Re: 360 Main Street - Zeidan Realty Corp. Amended Site Plan Application 360 Main Street (108.03-1-69)

In order to adequately address the comments received from the Planning Board and its consultants, we have prepared the following responses which address each of the comments contained in the Town Planner's memorandum dated November 14, 2022.

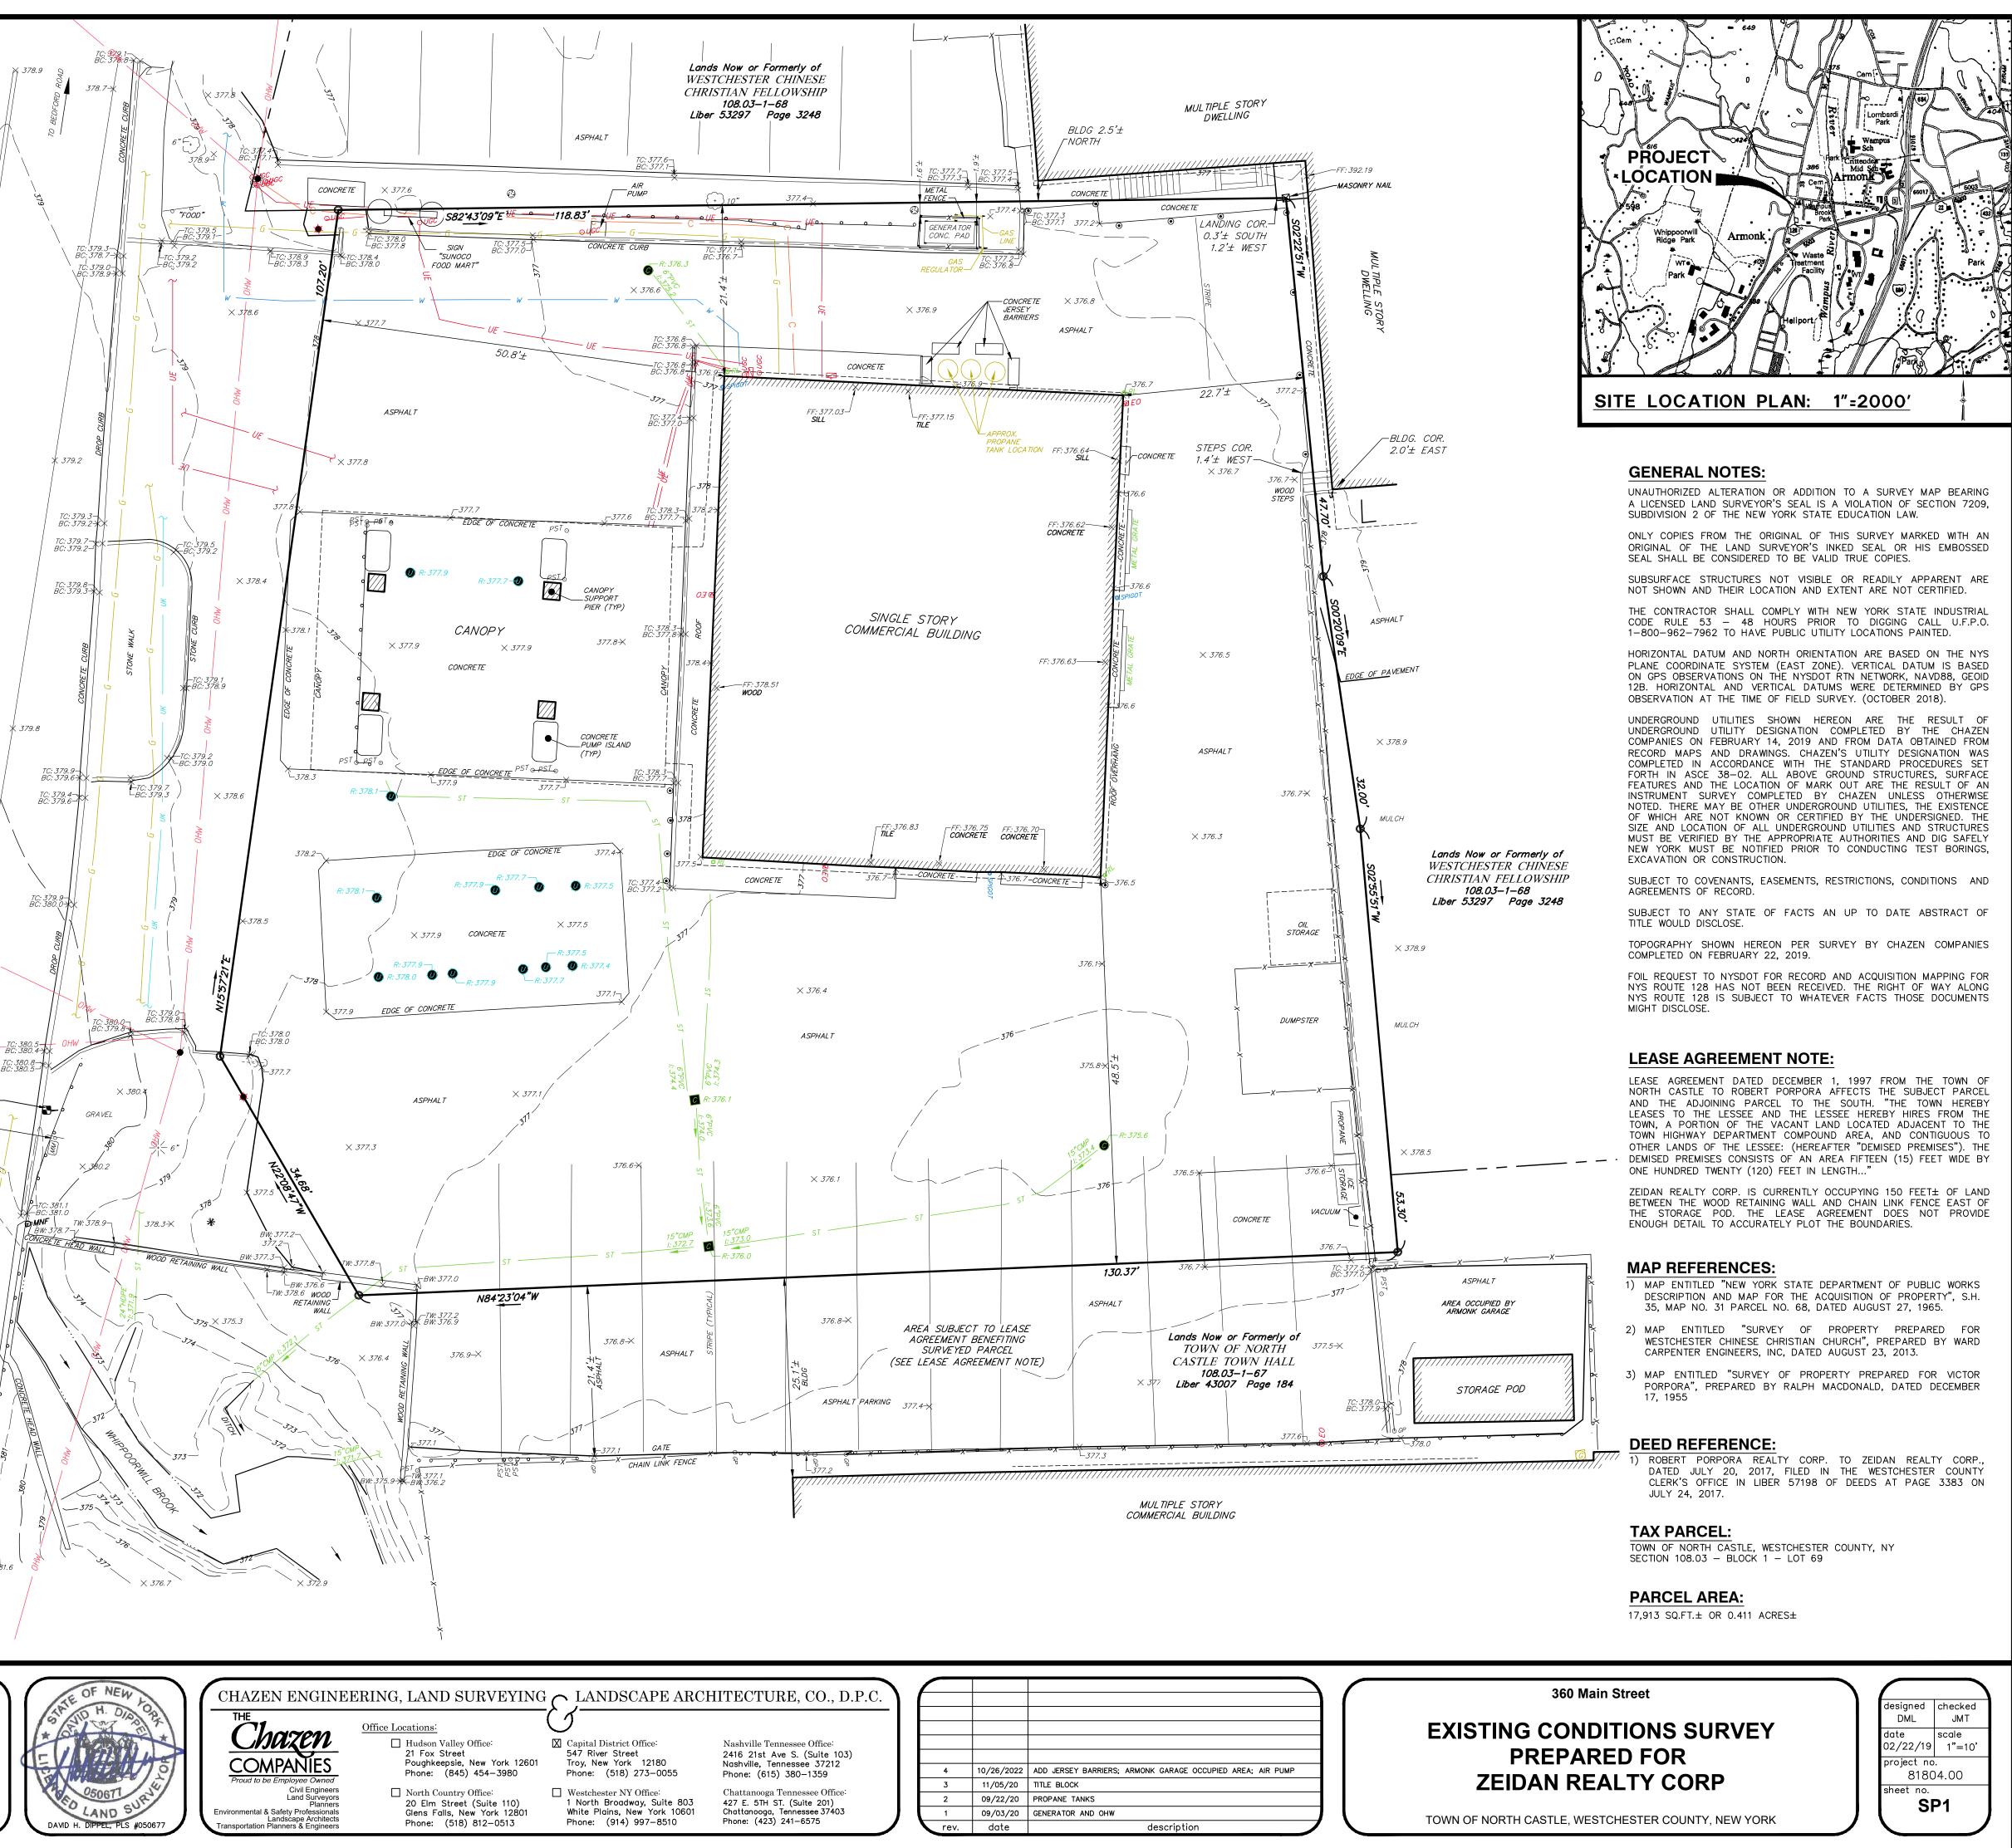
Comment 6: The proposed vacuum and ice storage box are depicted to be partially within a fenced area. If the existing fence is proposed to be removed, the site plan should be revised to include a note stating such. If the fence is proposed to remain, the Applicant should clarify what exactly is proposed.

Response: We have reviewed sheet C130 and there is no fence in the area of the existing vacuum and ice storage box area, nor are we proposing one as part of this plan. It is presumed that the concrete pad perimeter was misunderstood to be a fence. No change to the vacuum and storage box area is being proposed. The concrete pad in front of this area has been further labeled to show extents on the survey map.

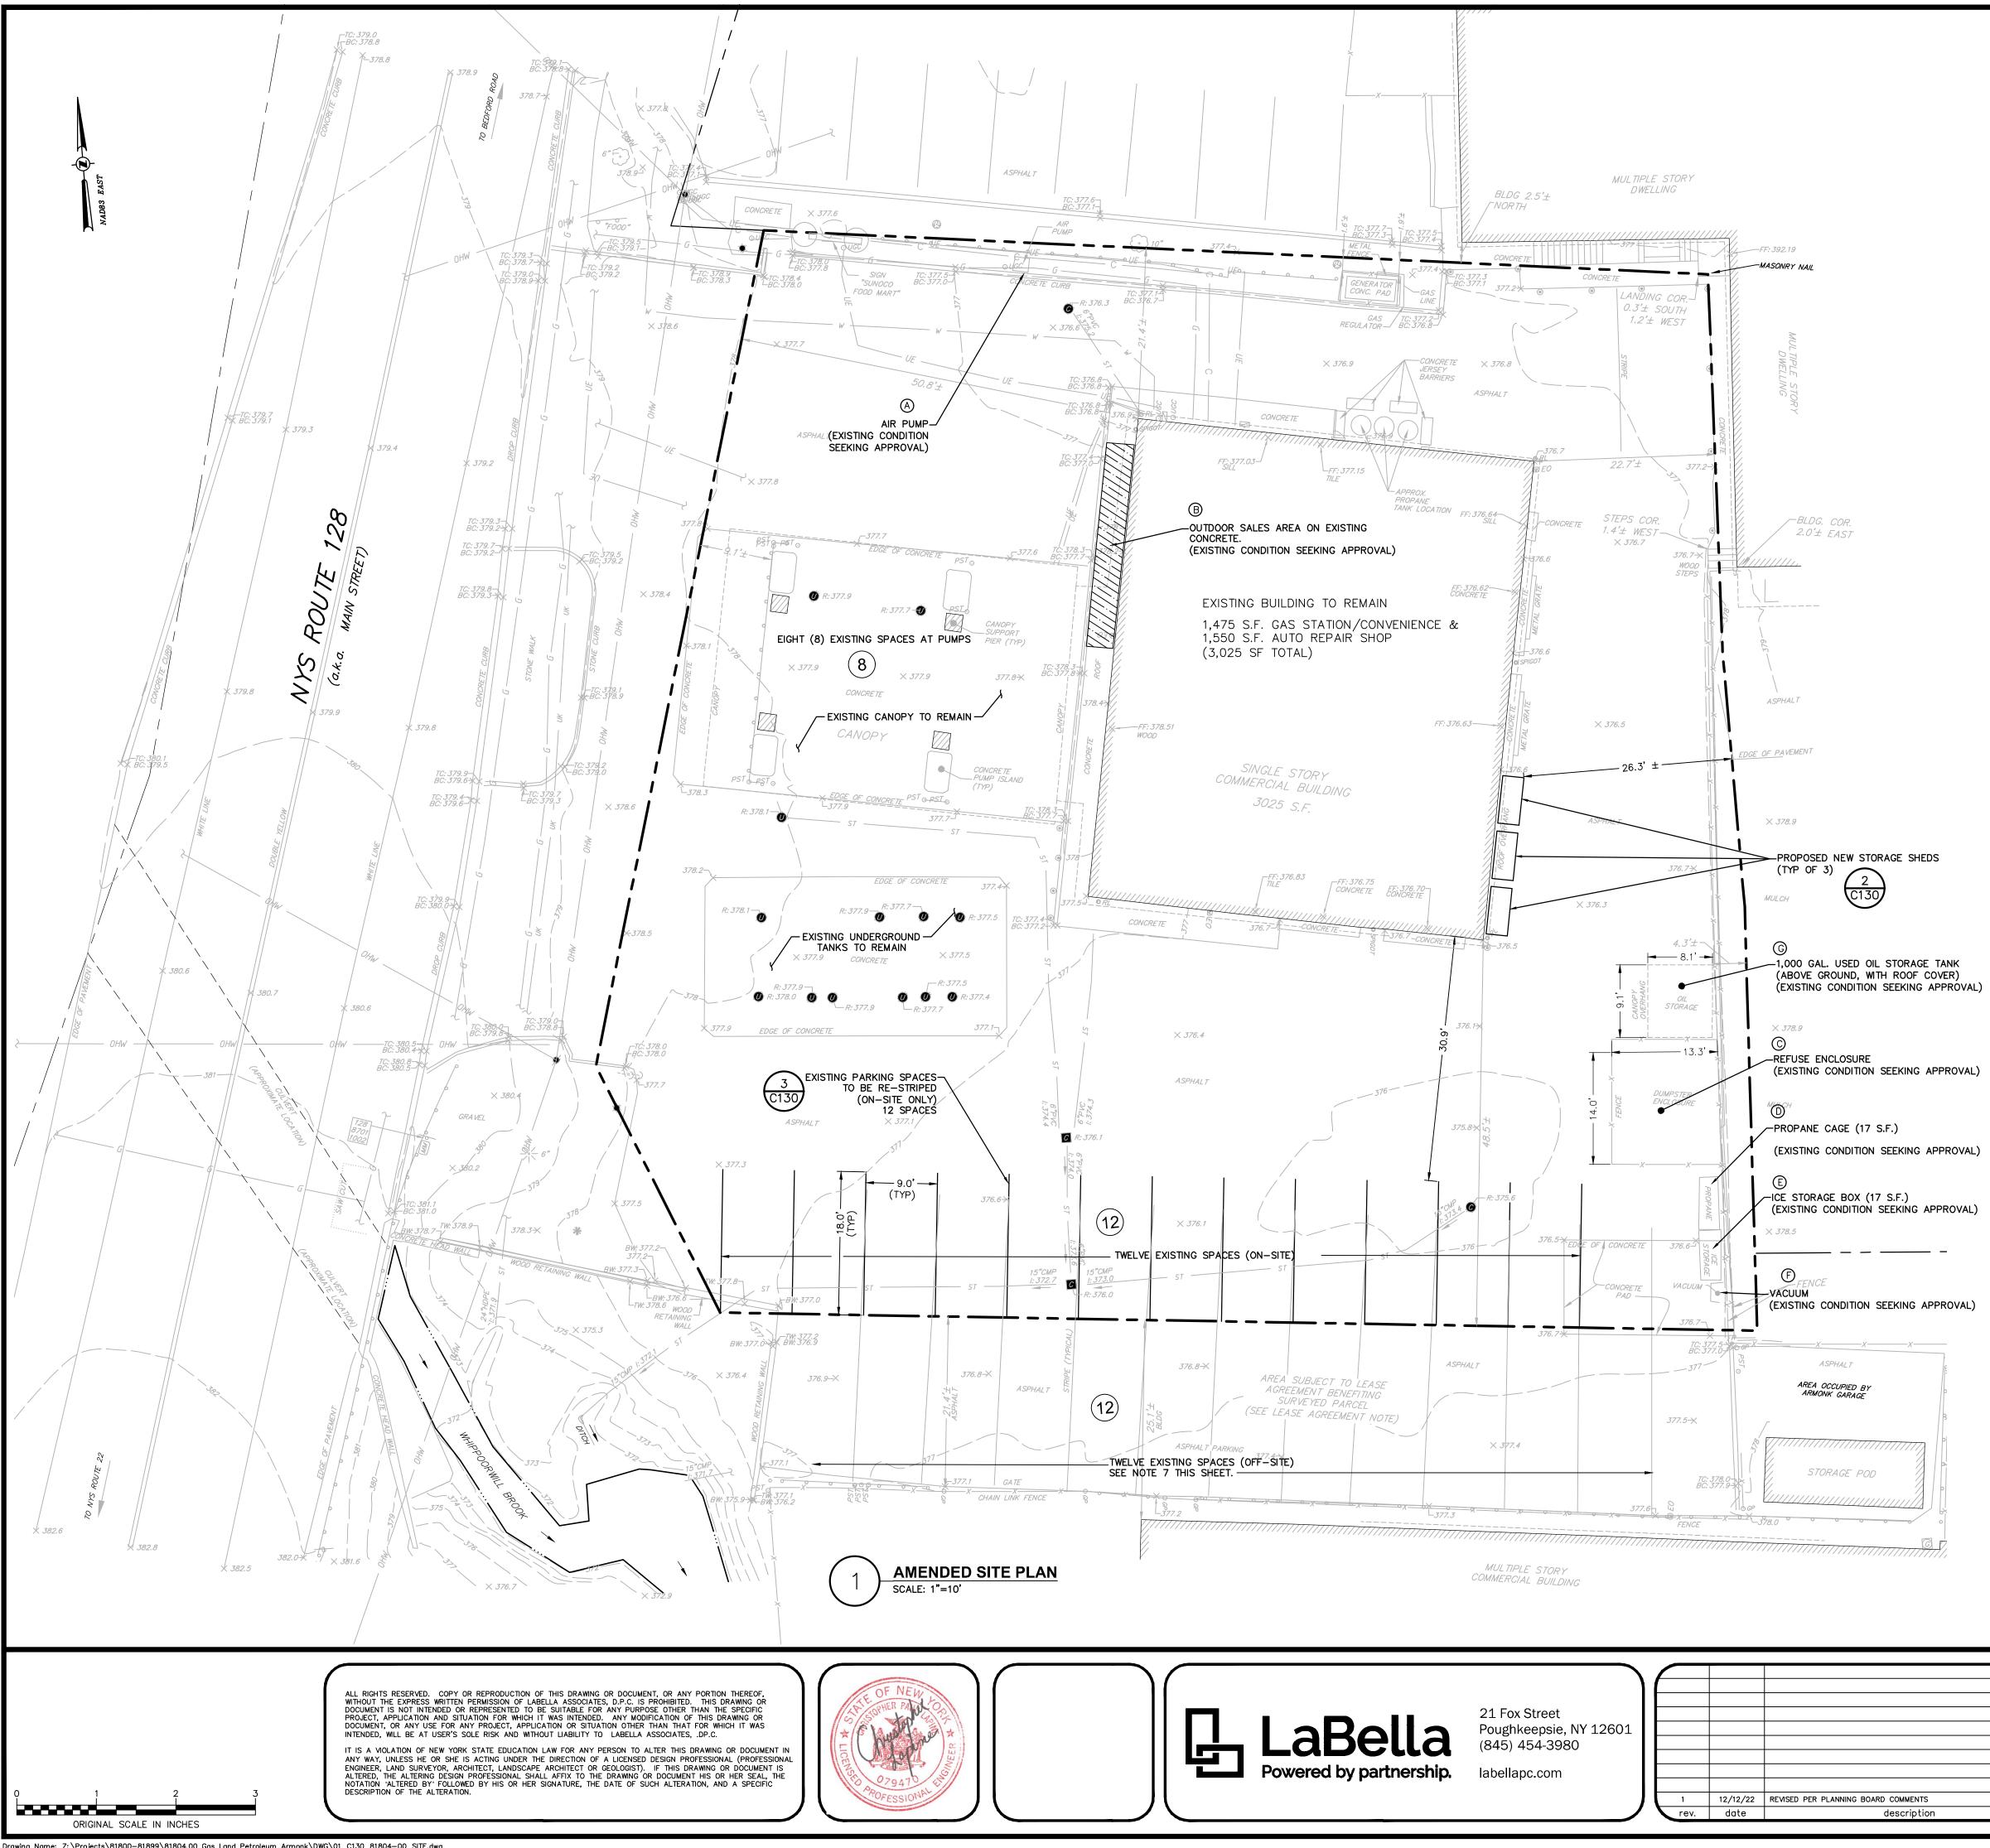
Comment 7: The site plan depicts a proposed 1,000 gal oil storage tank that is proposed to be covered. A detail of the tank and roof should be submitted for review. The proposed structure would not appear to meet the rear yard setback requirement.

Comment 8: The site plan should be revised to include a detail of the proposed refuse enclosure.

Comment 9: The site plan should include a detail of the proposed ice storage box.

Comment 10: The site plan should include a detail of the proposed vacuum.

Comment 11: The site plan should include a detail of the proposed air pump.

Comment 14: The off-street parking analysis states that 32 off-street parking spaces are provided; however, the submitted site plan only depicts 12 spaces. The chart should be revised.

Comment 17: The Applicant stated that outdoor display and sales is proposed. While outdoor sales and display is subject to a Town Board special use permit, the site plan should also be revised to depict the location, design and material proposed to be displayed and sold.

Response: A photo of the existing condition seeking approval is provided on the Amended Site Plan. As shown, there is an existing canopy in place. Therefore, no detail has been provided. The structure does not comply with the rear yard setback requirement. The Applicant will pursue a

variance. The used oil tank has a rain barrier roof made of metal posts with a corrugated plastic roof canopy.

Response: A photo of the existing condition seeking approval is provided on the Amended Site Plan. As shown, the dumpster is enclosed with a metal chainlink fence with privacy slats.

Response: A photo of the existing condition seeking approval is provided on the Amended Site Plan. Pursuant to discussions that have been held with the Building Inspector, it is the Applicant's understanding that so long as the ice storage box is under 64 s.f., it is not considered a structure requiring a setback. The ice storage box is approximately 17 s.f.

Response: A photo of the existing condition seeking approval is provided on the Amended Site Plan. Pursuant to discussions that have been held with the Building Inspector, it is the Applicant's understanding that so long as the vacuum is under 64 s.f., it is not considered a structure requiring a setback. The vacuum is approximately 4 s.f.

Response: A photo of the existing condition seeking approval is provided on the Amended Site Plan. Pursuant to discussions that have been held with the Building Inspector, it is the Applicant's understanding that so long as the air pump is under 64 s.f., it is not considered a structure requiring a setback. The air pump, located at the northern portion of site, sits on a 3.2 s.f. concrete pad.

Response: Please see notes added to sheet C130 clarifying a total of 32 parking spaces (20 on-site spaces, and 12 located on adjacent site which is currently leased by applicant's tenant). No work is proposed to the adjacent site. Additionally, Sheet G001, Bulk Table Footnote #6 indicates the 12 off-site spaces.

Response: A photo has been added to the Site Plan showing the location, design, and material existing condition seeking site plan approval. The Applicant's outdoor sale's display is for firewood, salt, and windshield washer fluid. These materials will continue to be displayed directly in front of the convenience store.
